September 1, 2026

RE: Atticus Woods
Project Number: PSP-26-0002
Response to 1st PSP Plan Review Comments
LEN24019

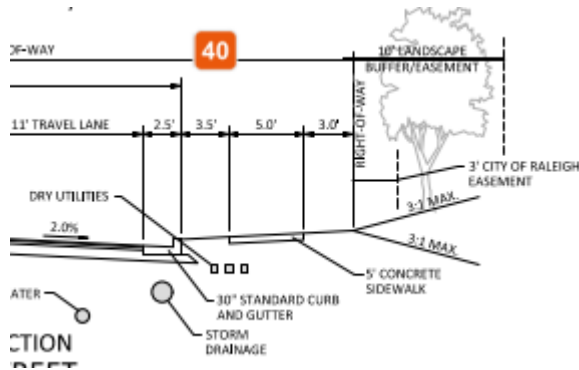
38. Revised to SFA (Townhome) Guest

McAdams Response: Wording has been revised in the parking table.

C0.01 PROJECT NOTES

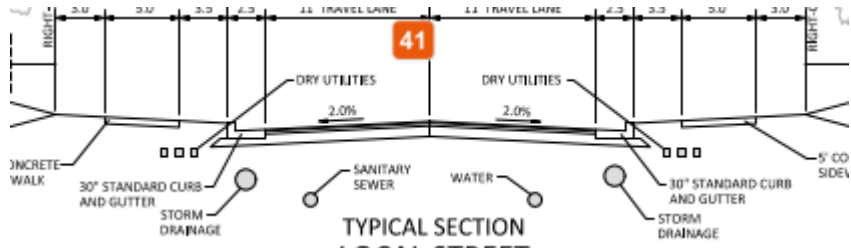
40. Per the Town's Standards Manual, a utility strip shall be provided between the back of curb and sidewalk at a width of 5' - dry utilities should be located within this space and not under the sidewalk. This comment applies to both residential collector and local streets.

McAdams Response: Adjusted street section to comply with the Town's standards.

C0.02 OVERALL OPEN SPACE PLAN

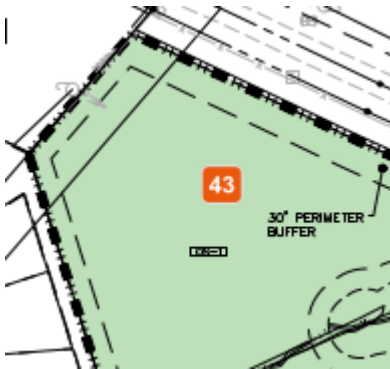
42. Please identify future amenity center site.

McAdams Response: Future amenity site has been identified as OS Area #11 on C2.00 in the open space areas summary table.

C2.05 PRELIMINARY PLAT AND PAVEMENT MARKING PLAN – AREA “E”

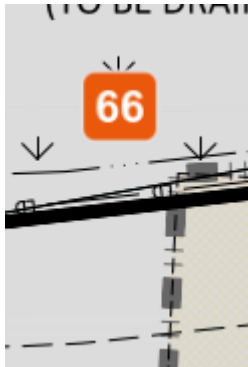
65. Does wall encroach on the lot area? There should be an HOA easement if so. Add note that the wall is the responsibility of the HOA.

McAdams Response: Added wall easement to lots 89-91.

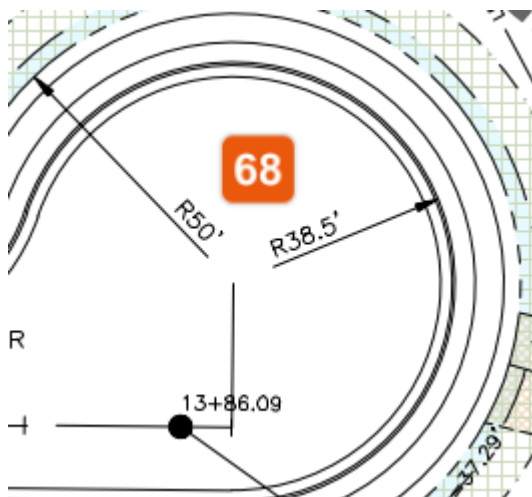
- | Fire Department access roads shall meet provisions of the Fire Code for emergency operations.
- | Street width shall be a minimum of 20 ft wide with an all-weather surface capable of withstanding imposed loads of fire apparatus weighing at least 80,000 lbs.

- | No vertical obstructions within 13 ft 6 inches over roadway which includes tree branches, signs or gates.
- | Grade shall meet minimum DOT standards and not exceed 10% grade.

- | Turning radius shall be sufficient to allow emergency vehicle access without stopping and repositioning.
- | Road widths where a hydrant is located shall be a minimum of 26 ft.

- | Dead end roads over 150 ft in length shall have 60 ft hammerhead turn around provided. If temporary due to phased construction, then a temporary turnaround shall be provided.

- | If entrance gate provided then immediate emergency vehicle access shall be provided.
- | Gated entrances shall have a minimum of 12 ft roadway width in each direction or if one gate then a minimum of 20 ft width.

- | Buildings over 30 ft in height above fire department access road shall have 26 ft wide access roads for aerial apparatus.
- | Fire lane marking may be required in areas near building and around hydrants to provide unobstructed access.

- | Alleys serving the front door of residence shall be name for E911 addressing and meet the same requirements as all other roads

McAdams Response: Thank you for the notes. We will make sure that our subdivision design complies with the fire code requirements you listed above.

C2.06 PRELIMINARY PLAT AND PAVEMENT MARKING PLAN – AREA “F”

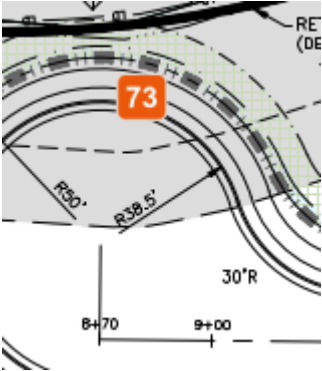
72. Retaining walls appear to be within zone 1 of the riparian buffer

McAdams Response: With the existing pond being drained we feel confident that when the pond is redetermined, the retaining wall will no longer be in the buffer. A note has been added to affected areas referencing that development is dependent on future delineation.

C3.00 OVERALL GRADING AND STORM DRAINAGE PLAN

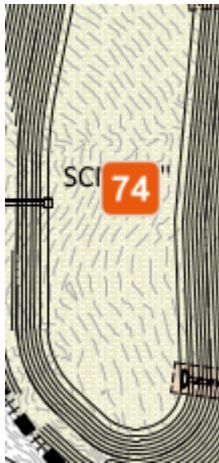
74. General comment: How are these SCM's accessible from a public right of way for future cleanout

McAdams Response: Added access paths to SCM with grading.

C3.01 GRADING AND STORM DRAINAGE PLAN – AREA “A”

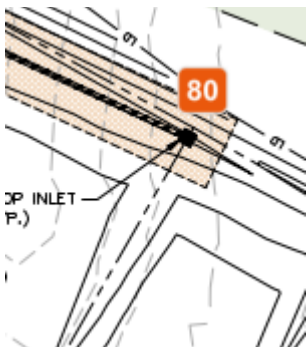
78. Please review intersection design to ensure contours are not developing potential low points.

McAdams Response: Removed low spot from intersection.

C3.02 GRADING AND STORM DRAINAGE PLAN – AREA “B”

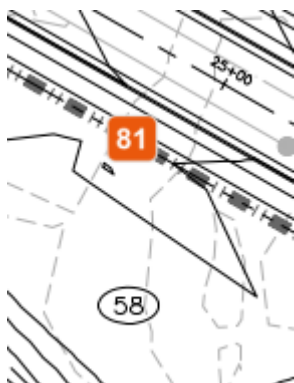
80. all drainage easements not carrying "public water" to be private

McAdams Response: Modified drainage easements to public drainage easements.

C3.04 GRADING AND STORM DRAINAGE PLAN – AREA “D”

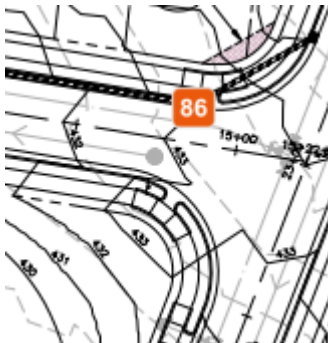
86. Review all CB locations to ensure they are constructable with the curb and gutter/ADA compliance. There are several located within or right at pedestrian ramps which will not be able to work.

McAdams Response: CBs have been moved off of the pedestrian ramps, and more space was given to allow for the curb transitions.

C3.05 GRADING AND STORM DRAINAGE PLAN – AREA “E”

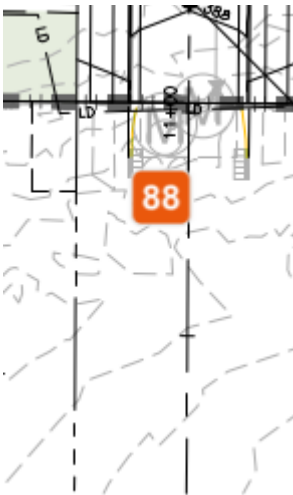
88. Show existing conditions to ensure widths/transitions are occurring properly, including existing grading. It appears additional survey may be needed since this is an existing roadway but contours don't reflect a road.

McAdams Response: Noted. We are working on getting updated survey for the tie in roads and will update the plans and grading accordingly.

C3.06 GRADING AND STORM DRAINAGE PLAN – AREA “F”

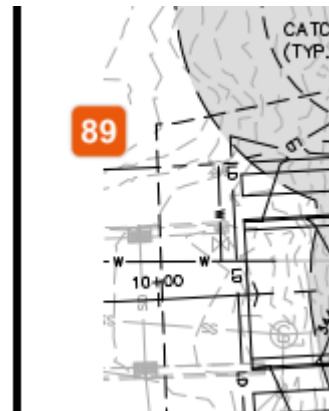
89. Existing Sidewalks are not shown. Please show all existing conditions to ensure tie ins are correct.

McAdams Response: Noted. We are working on getting updated survey for the tie in roads and will update the plans and grading accordingly.

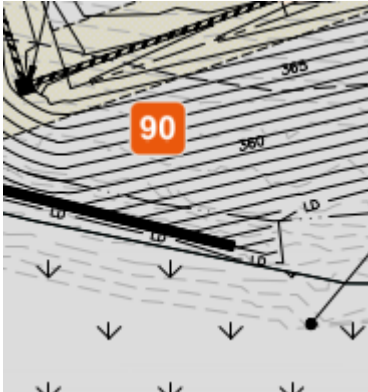
90. Retaining wall appears to be in Zone 1 of the riparian buffer.

McAdams Response: The existing pond is to be drained, so the buffer will be removed from that area.

C4.00 OVERALL UTILITY PLAN

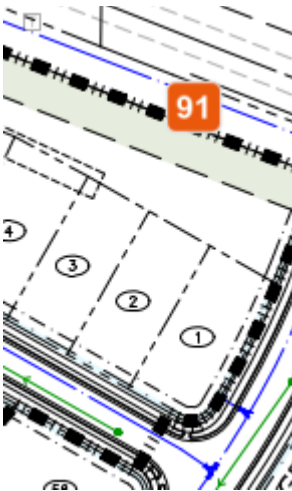
91. Revise to show 10' wide sidepath and label.

McAdams Response: 10' pathway is now showing along Wait Avenue.

L5.02 LANDSCAPE PLAN – AREA “B”

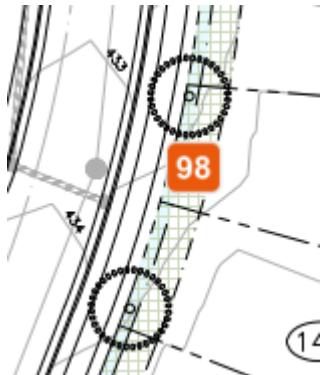
97. Show required NCDOT improvements

McAdams Response: As recommended by previous comment, detailed landscape plan enlargements are not required at the preliminary subdivision plan stage. This comment will be addressed during the Construction Document review. An overall landscape plan will be provided for reference with the preliminary subdivision plan, but the detailed enlargements and full landscape design will be forthcoming with the future submittal of construction documents.
